# HISTORIC AND DESIGN REVIEW COMMISSION

**HDRC CASE NO:** 2017-467  
**ADDRESS:** 423 N HACKBERRY ST  
**LEGAL DESCRIPTION:** NCB 576 BLK 15A LOT N 30.32 FT OF 12  
**ZONING:** RM-4 H  
**CITY COUNCIL DIST.:** 2  
**DISTRICT:** Dignowity Hill Historic District  
**APPLICANT:** John Brearley  
**OWNER:** John and Irene Brearley  
**TYPE OF WORK:** New construction of a 2-story single family home  
**REQUEST:**

The applicant is requesting conceptual approval to construct a new two-story single family home on the vacant lot at 423 N Hackberry St.

FRONT ELEVATION

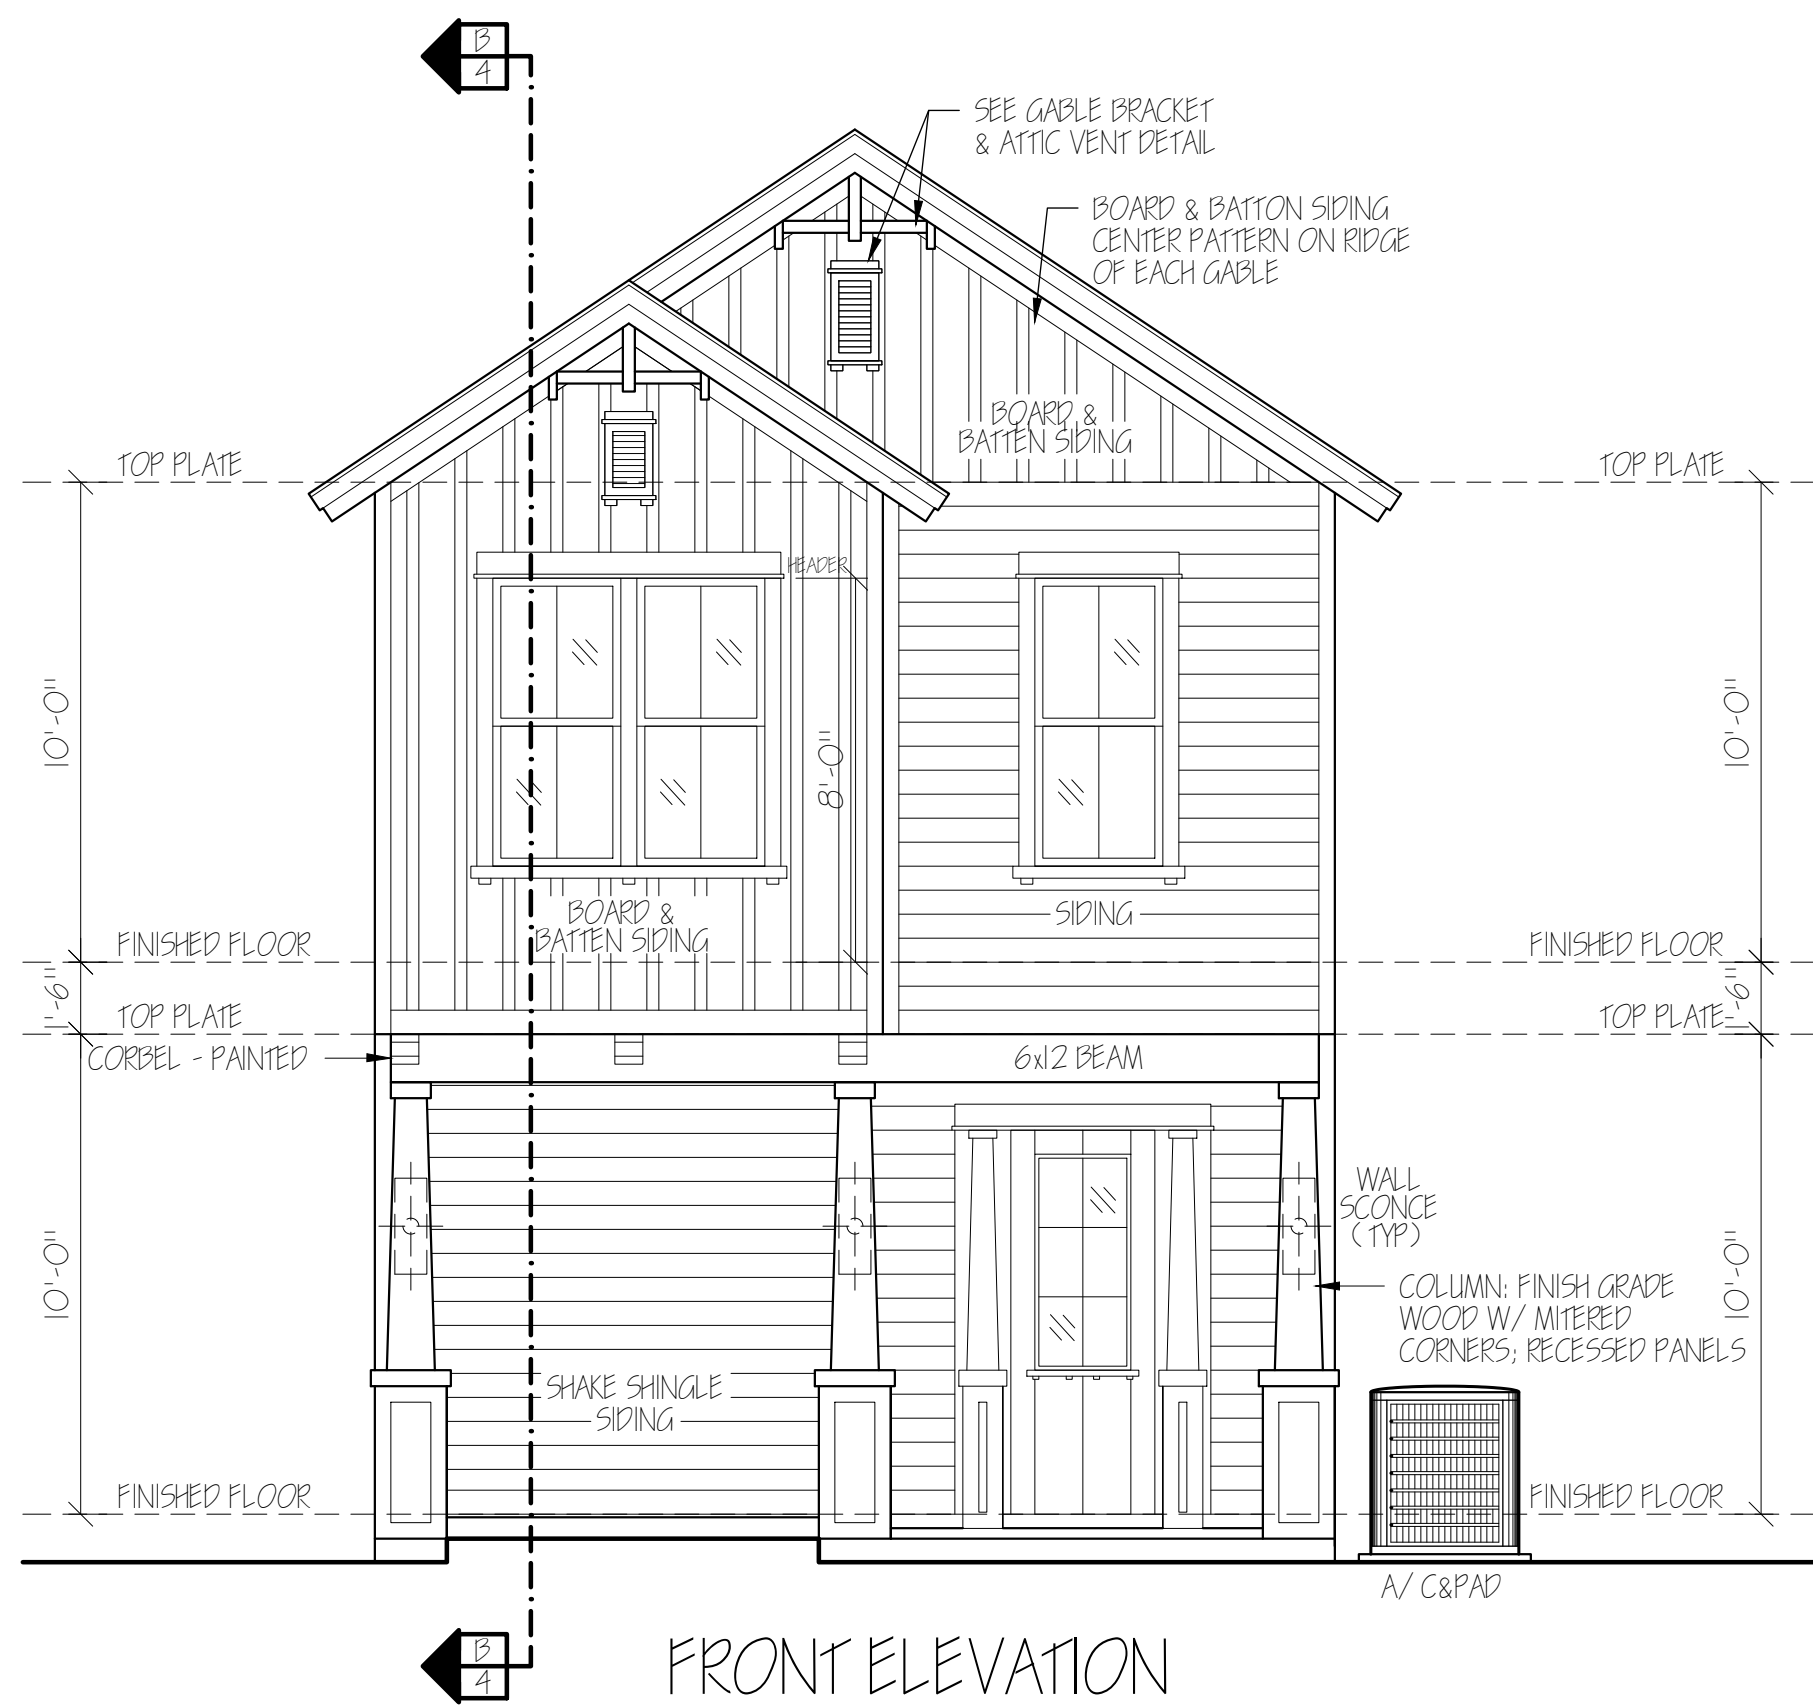
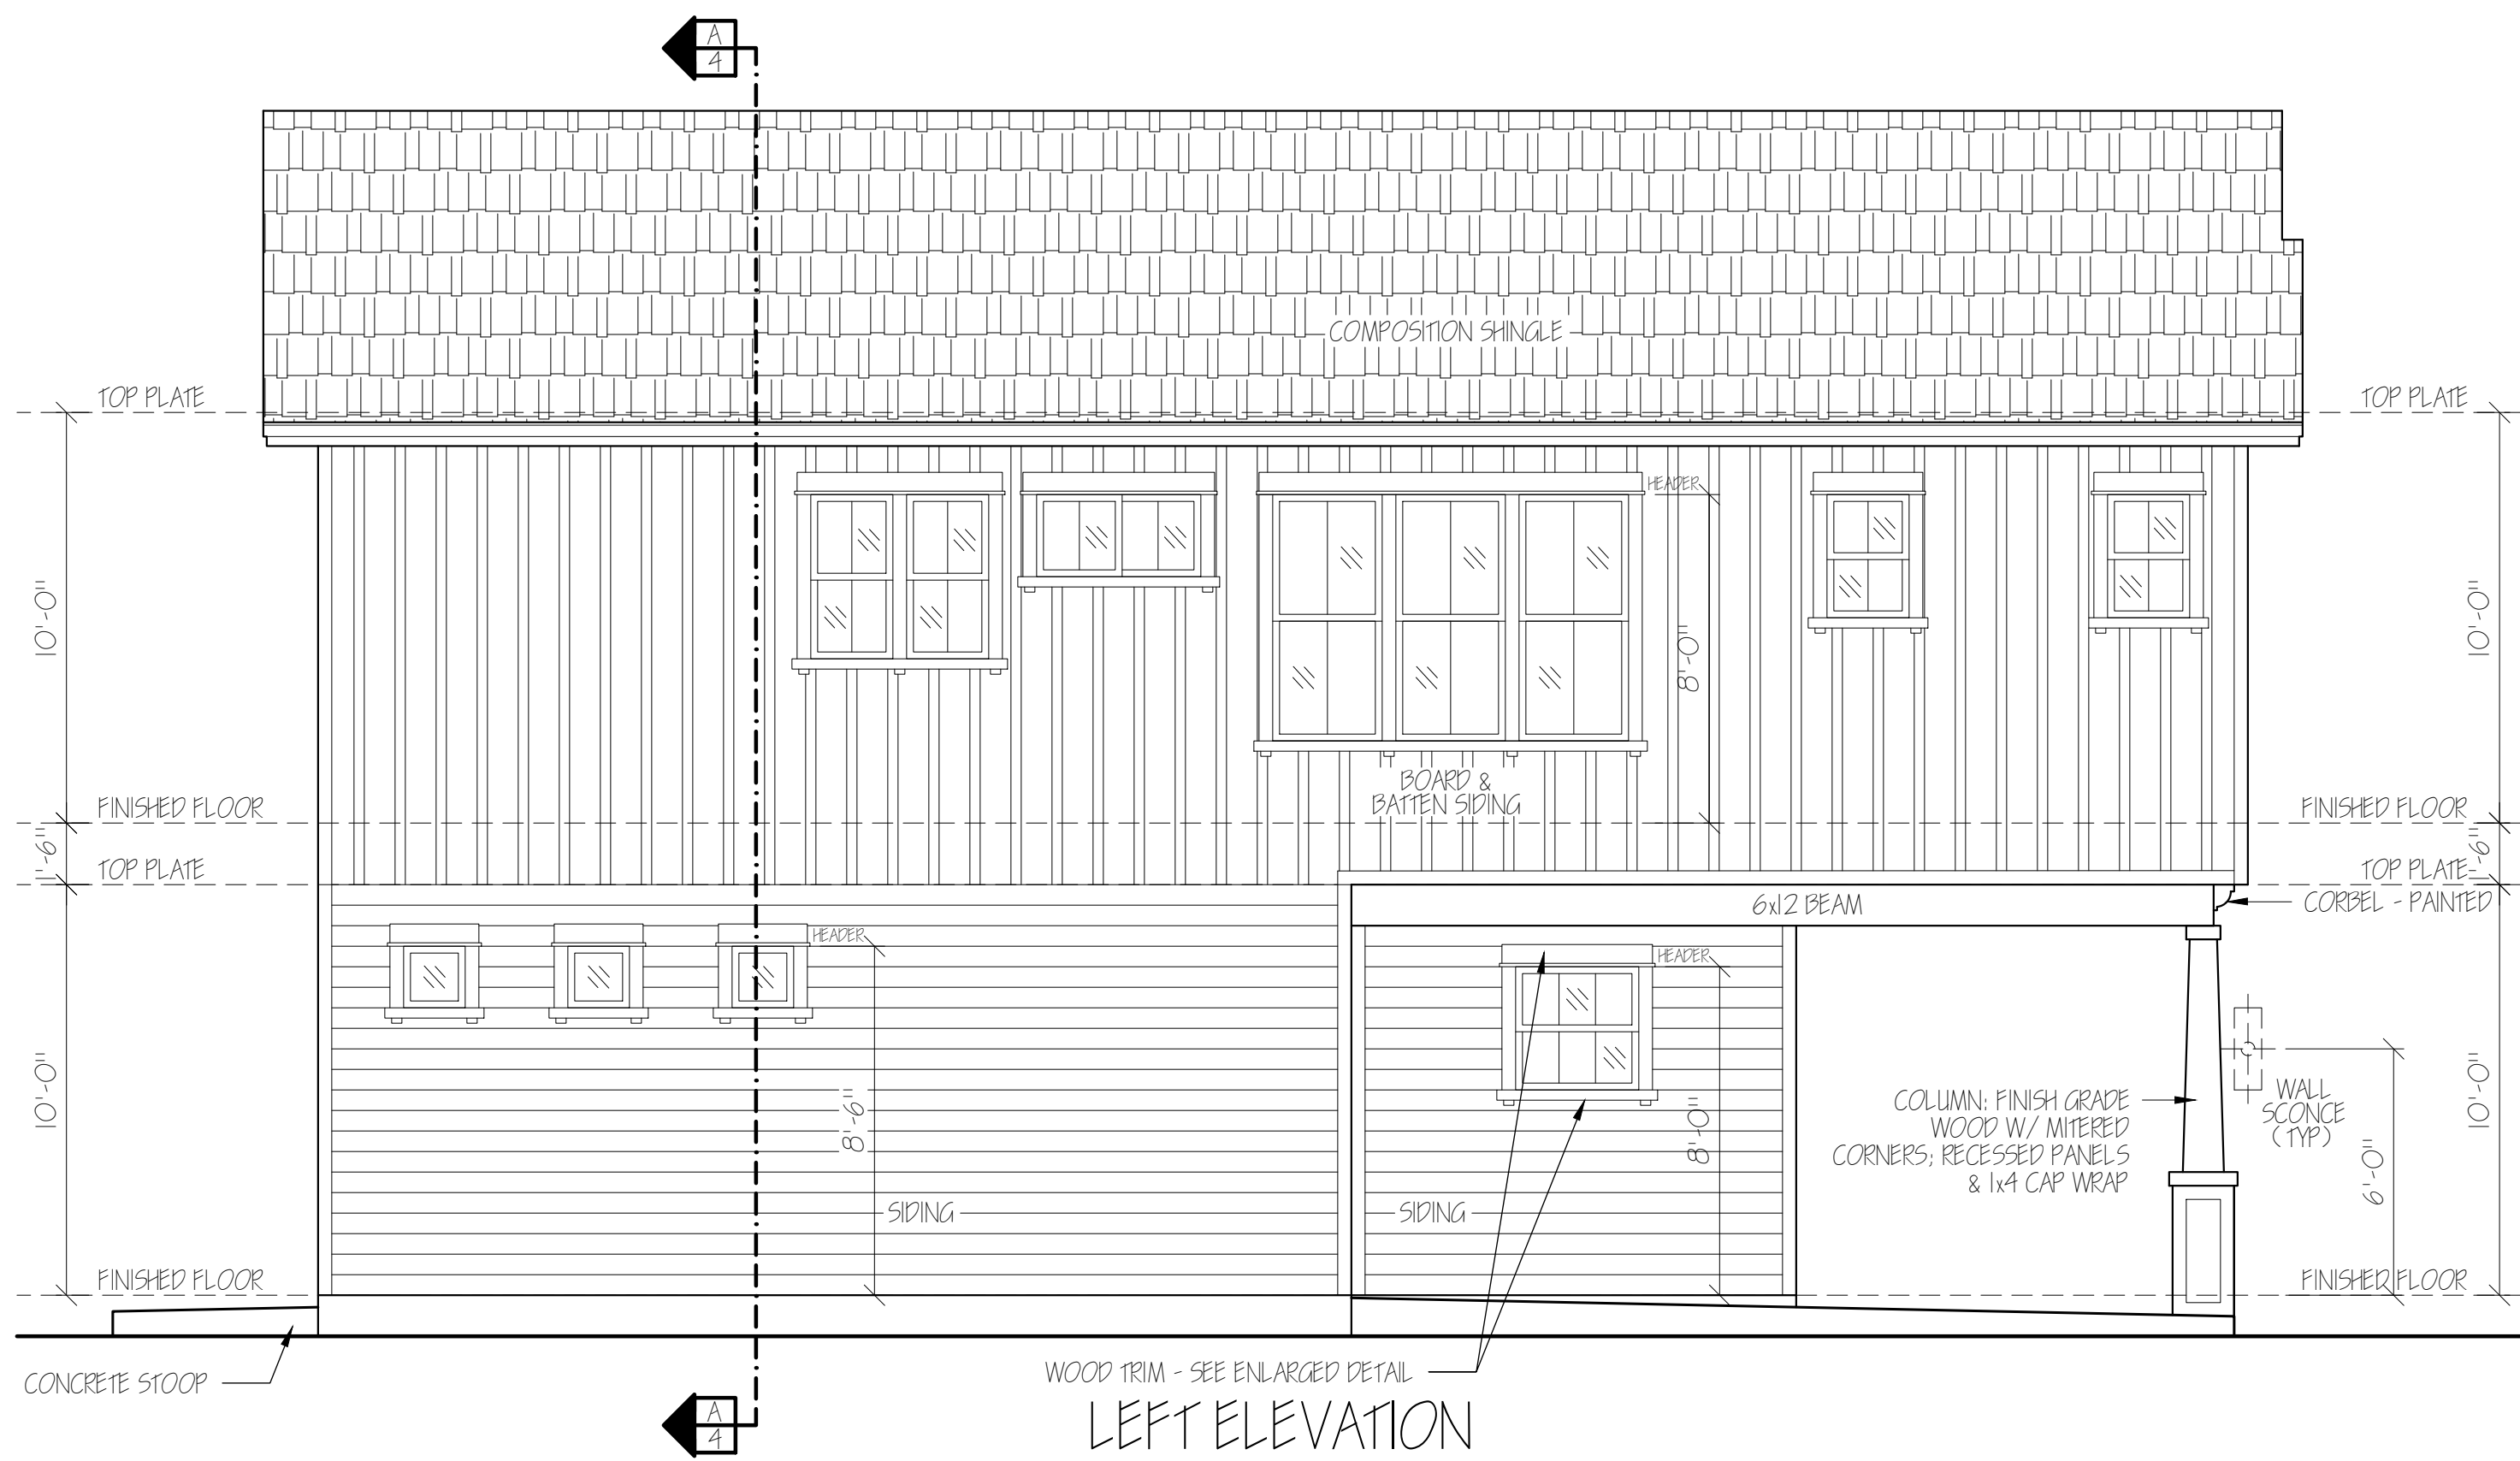
- f. **SCALE & MASS** – Per the Guidelines for New Construction 2.A.i., a height and massing similar to historic structures in the vicinity of the proposed new construction should be used. In residential districts, the height and scale of new construction should not greatly exceed the historic precedent. The only remaining historic residential structure on N Hackberry between E Houston and Glorietta is 2 stories. The remaining historic structures in the vicinity on Glorietta are 1-story. The applicant has noted on the submitted drawings that the proposed ridge line will be 28'-10" from the finish floor, which is approximately one foot from grade, bringing the total height to approximately 29'-10" feet. Both the first and second stories will feature 10'-0" tall interior ceiling heights separated by a web truss measuring 1'-6". The neighboring 2-story historic structure features a first floor ceiling height of 10'-0" and a second floor ceiling height of 8'-0". Staff does not find the proposed height to be consistent with the Guidelines. Staff finds that the overall height should be reduced through the shortening of the second story or the lowering of the top plate height to produce an overall height that is comparable with the heights of neighboring, historic structures.

- g. **PORCH CONFIGURATION AND MASSING** – The applicant has proposed to incorporate a front porch on the front façade of the new structure. The porch mass will be inset approximately 6" from the front façade. The Historic Design Guidelines state that porches on new construction should be reflective of the development pattern of the district. Typically in historic districts, including Dignowity Hill, residential porch massing elements project the furthest towards the streetscape to engage pedestrians. Two story structures feature a second story that is set back from the porch. As proposed, the structure's second story extends over the front porch, which increases the massing on the street. This is addressed in Guideline 2.A.ii, which states that step-downs in building height, wall-plane offsets, and other variations in building massing to provide a visual transition should be utilized. There is no historic precedent in the district for this porch form or massing strategy. Staff finds the porch inconsistent with the Guidelines.

- h. **FOUNDATION & FLOOR HEIGHTS** – According to the Guidelines for New Construction 2.A.iii., foundation and floor height should be aligned within one (1) foot of neighboring structure's foundation and floor heights. The applicant has noted that the foundation will be slab-on-grade and have a minimal height. Historic structures on this block feature foundation heights of approximately eighteen (18) to twenty-four (24) inches. This is generally inconsistent with the Guidelines and the surrounding context.

- j. **WINDOW & DOOR OPENINGS** – Per the Guidelines for New Construction 2.C.i., window and door openings with similar proportions of wall to window space as typical with nearby historic facades should be incorporated into new construction. The applicant has proposed window and door openings that are generally consistent with those found on historic structures in regards to location and size with the exception of the right and left elevations, which feature several small fixed windows that are not consistent with the OHP Window Policy Document or historic fenestration precedents in the district, as well as a series of ganged windows with minimal trim separation between them. All proposed window detailing can be modified to relate closer to historic examples, such as the use of approximately six inches of separation between double windows. Each window should be inset at least two (2) inches within walls to ensure that a proper façade depth is maintained.

1. That the applicant provides information noting the setbacks of adjacent historic structures on a contextual site plan.
2. That the applicant reduces the proposed height through the shortening of the second story or the lowering of the top plate height to produce an overall height that is comparable with the heights of neighboring historic structures.

3. That the applicant sets the second story back from the front façade and modifies the front porch configuration and massing as noted in finding g. The porch should be the mass that projects furthest towards the streetscape to reflect the developmental context of the area.

4. That the applicant explores ways to incorporate a raised foundation for a front porch or pedestrian entry to be more consistent with neighboring historic structures as noted in finding h, if feasible.

5. That the applicant explores ways to construct a driveway along the side of the proposed new construction as noted in finding p.
6. That the applicant introduces window sizes and proportions that are more consistent with the Historic Design Guidelines, the OHP Window Policy Document, and adjacent historic structures to the right and left elevations as noted in finding i.
